Rezoning Transportation Analysis

Petition Number: 2019-105

Date	Description
09-16-19	First Review

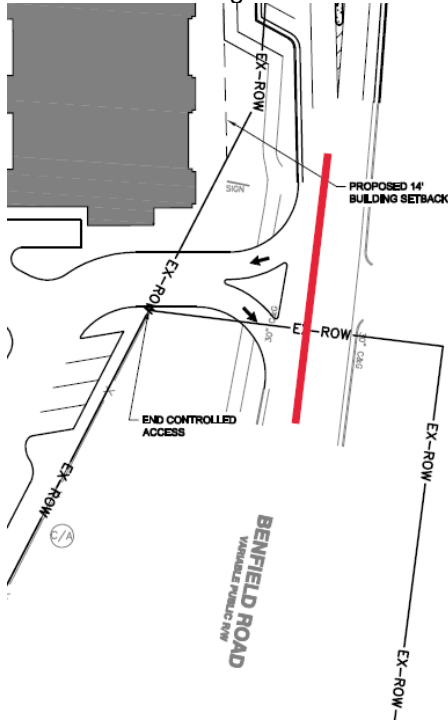
3. The petitioner should revise the site plan and conditional note(s) to remove the reverse angled parking along Benfield Road and Summer Creek Lane.
